**re: Grading and Site Servicing Plan Review**  
**Proposed Commercial Development**  
3700 Twin Falls Place, Block 2 – Ottawa, Ontario

**to: CSV Architects – Darryl Hood – [hood@csv.ca](mailto:hood@csv.ca)**

**file:** PG7255-MEMO.01

Figure 1 – Markup Site Servicing Plan for the Location of Pipes and Culverts Where Insulation Will Be Required.

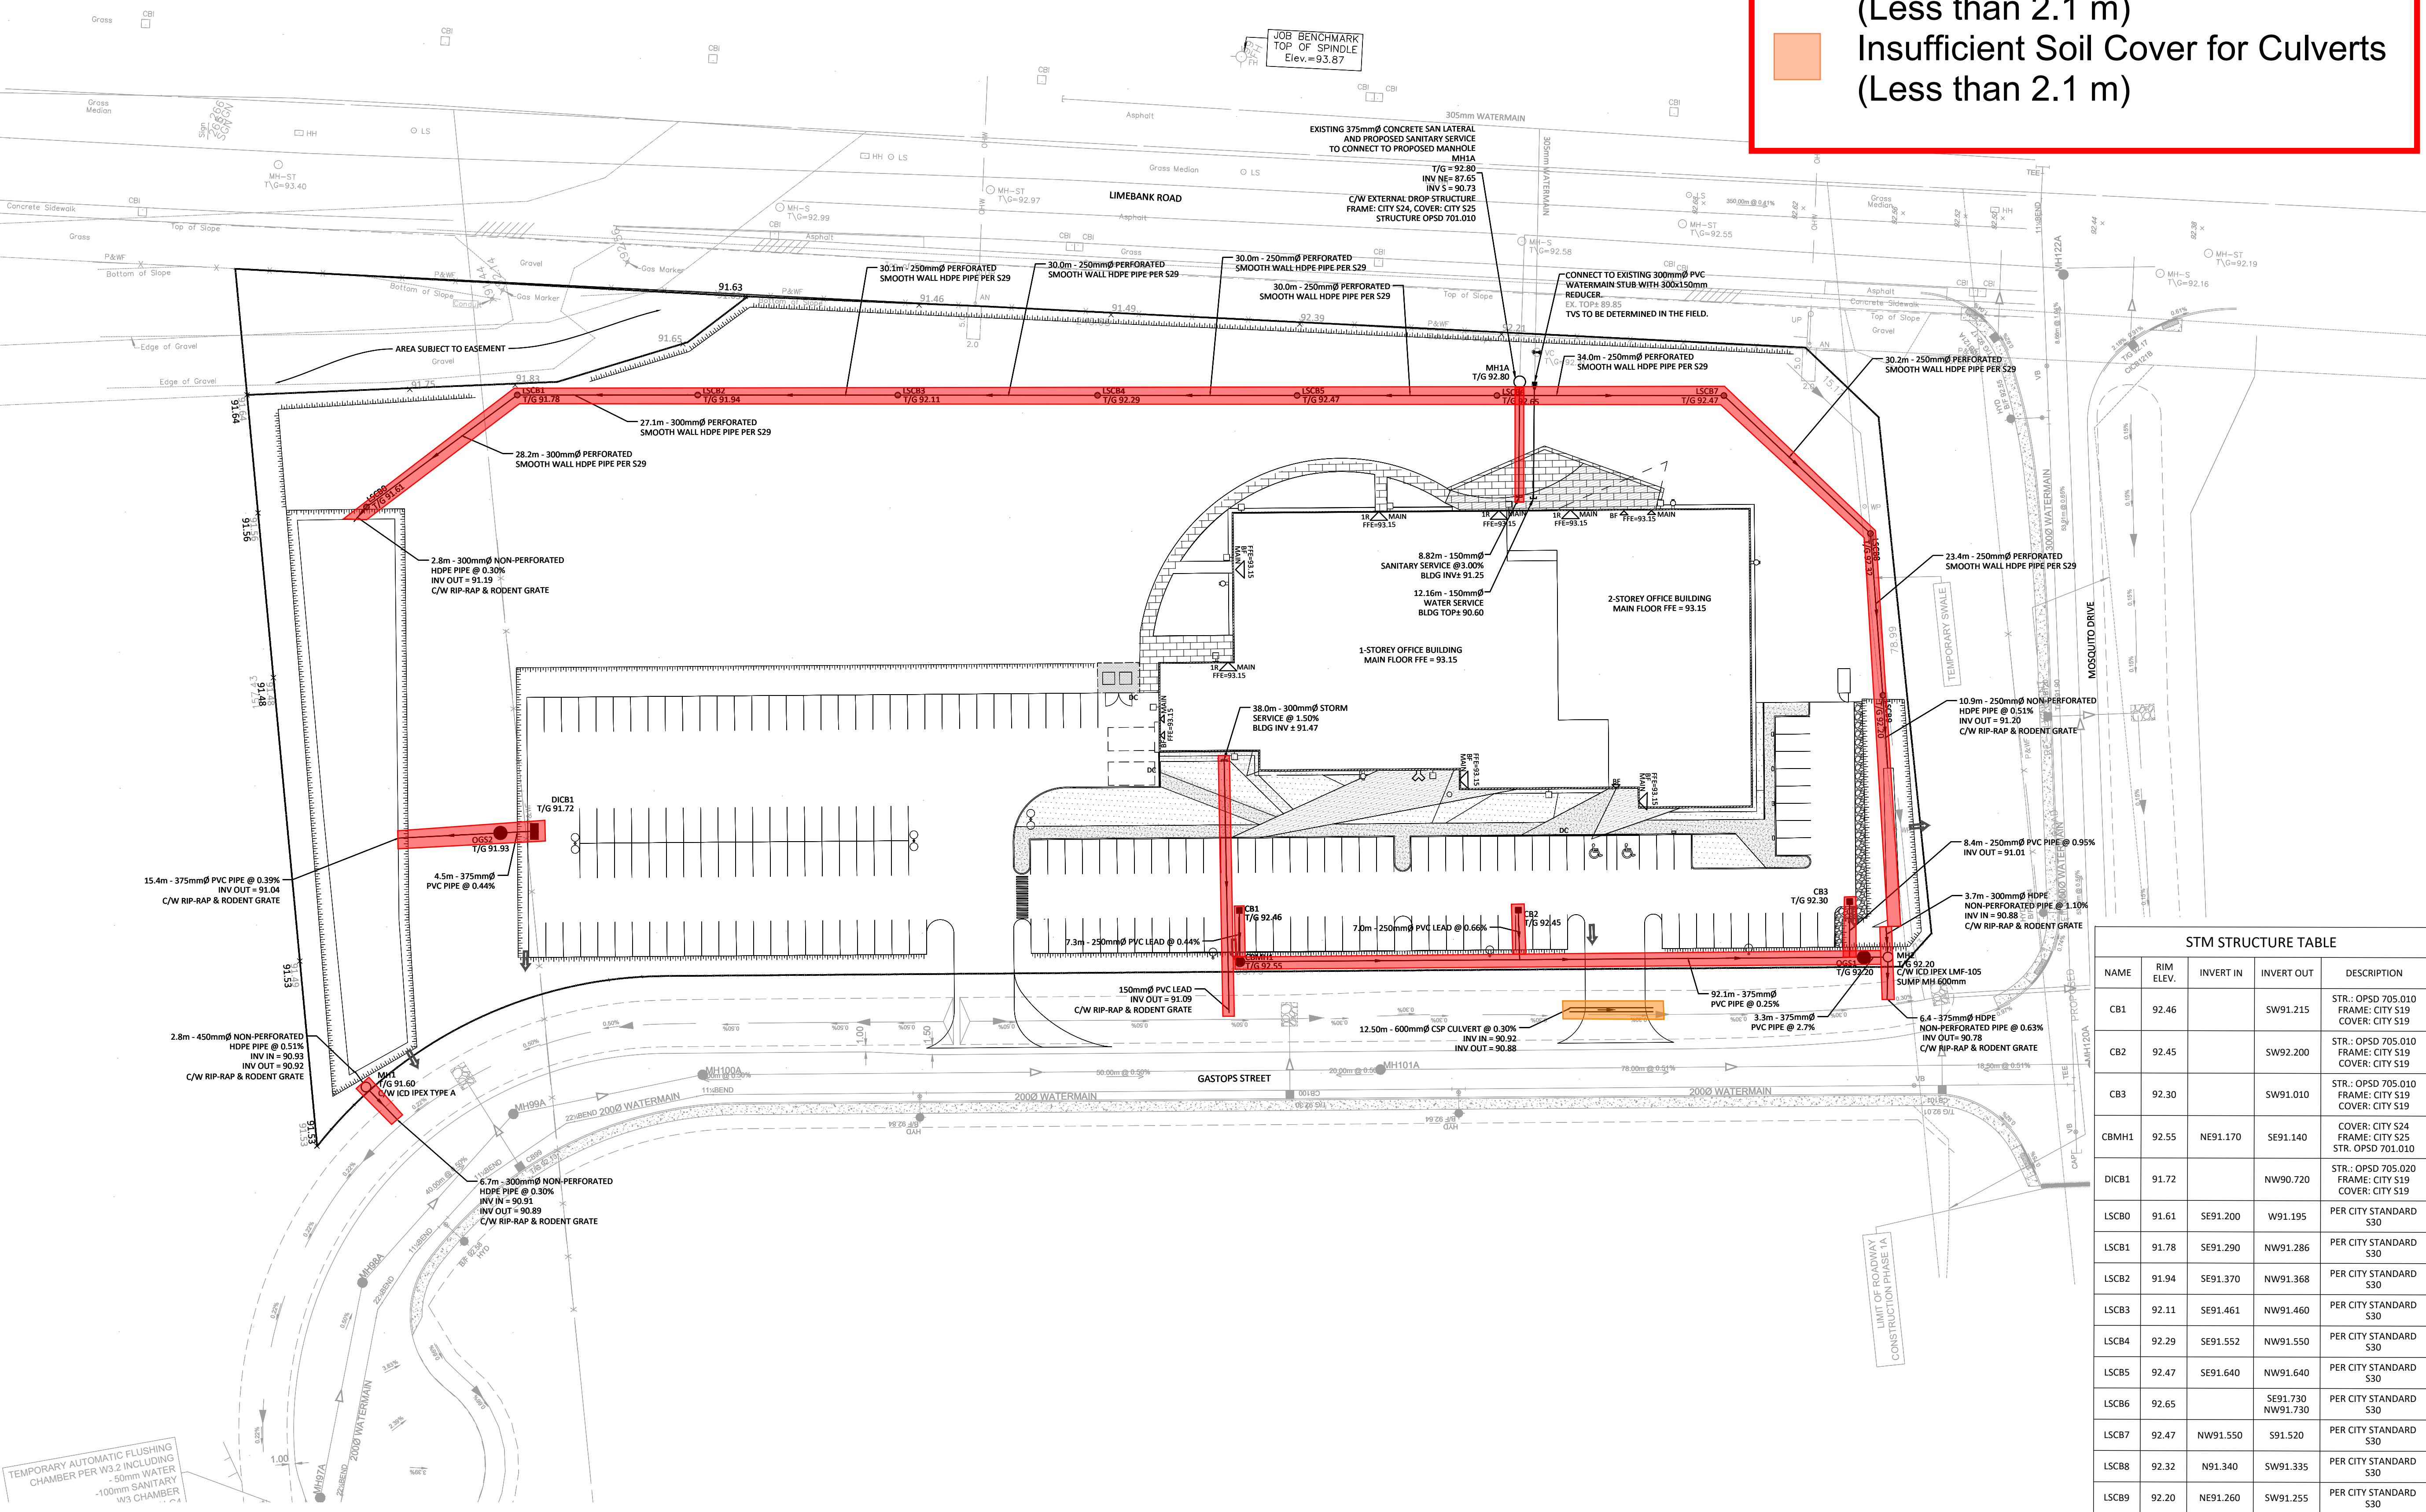
Based on our review of the above-noted site service plan, when assuming an approximate USF depth of 1.5 m, it should be noted that all services will be constructed outside the lateral zones of the proposed footings of the building and are considered to be acceptable from a geotechnical perspective. However, insufficient frost protection has been provided for the proposed storm and sanitary sewer pipes as well as the proposed culvert structures throughout the subject site. It should be noted that the elevation for the proposed connection to the existing watermain pipe was not available on the above-mentioned drawing. The watermain connection elevation should be reviewed by Paterson when available.

Reference should be made to Figure 1 – Markup Site Servicing Plan for the Location of Pipes and Culverts Where Insulation Will Be Required, attached to this memorandum.

It should be noted that the aforementioned storm and sanitary sewer pipes are located within the frost zone, which is 2.1 m below the finished grade. In the following section, frost protection of the site servicing is recommended where insufficient frost cover has been provided.

In addition, it should be noted that based on the invert elevation of the proposed culvert at the southwest side of the subject site and the proposed ground surface at this location, insufficient soil cover (less than 2.1 m) is provided for the culvert structure. Therefore, a minimum 75 mm thick layer of HI-40 rigid insulation or an approved equivalent should be placed directly above the native subgrade prior to the placement of the concrete culvert structure. The rigid insulation should extend a minimum of 600 mm horizontally beyond the edge of the culvert on all sides. The insulation should be placed flat and level over the subgrade with no gaps between sheets. The insulation placement should be reviewed in the field by Paterson at the time of placement.

Any portion of the services installed at a depth of 2.1 m below the finished grade or deeper are considered to have sufficient soil cover for frost protection. Where insufficient soil cover is present above the invert of storm and sanitary sewer pipes, the following frost protection criteria should be followed:

Thermal Condition	Soil Cover Provided (mm)	Insulation Dimensions	
		Thickness (mm)	Extension (mm)
Unheated	1800 to 2100	25	Extend 300 mm horizontally beyond the outer edge of the pipe
	1500 to 1800	50	Extend 600 mm horizontally beyond the outer edge of the pipe
	1200 to 1500	75	Extend 900 mm horizontally beyond the outer edge of the pipe
	900 to 1200	100	Extend 1200 mm horizontally beyond the outer edge of the pipe
	600 to 900	125	Extend 1200 mm horizontally beyond the outer edge of the pipe
	300 to 600	150	Extend 1500 mm horizontally beyond the outer edge of the pipe

## Typical Frost Insulation Detail for Servicing Pipes

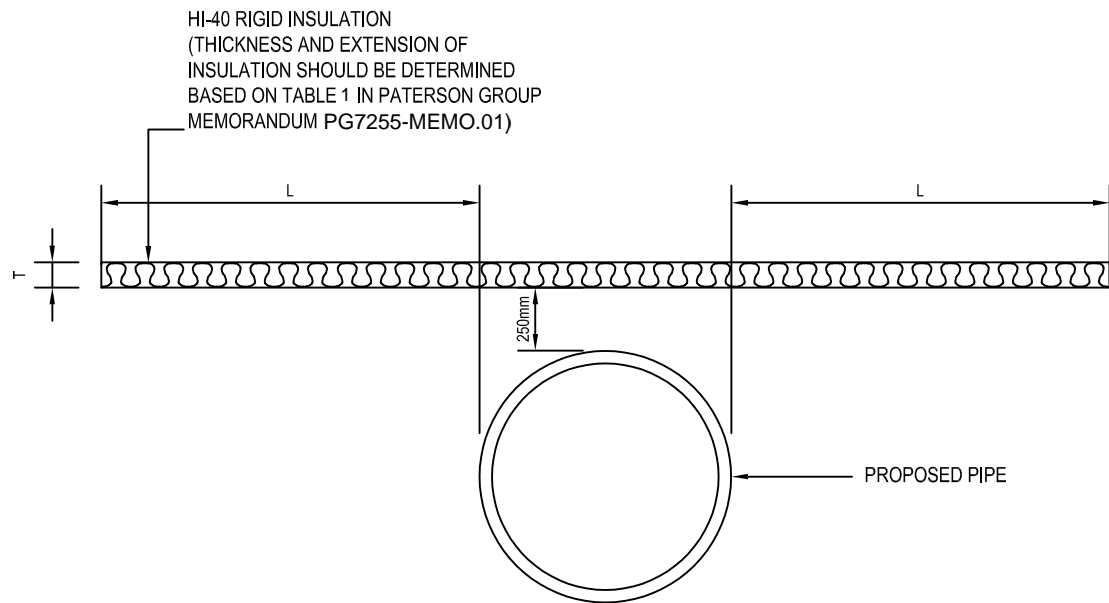
All rigid insulation should consist of either Dow Chemical High-Load 40 (HI-40), Styro Rail SR.P400, or equivalent approved by Paterson. The placement of all insulation within the service trenches must be reviewed and approved by Paterson personnel at the time of construction. Reference should be made to Figure 2 – Typical Frost Insulation Detail, attached to this memorandum.
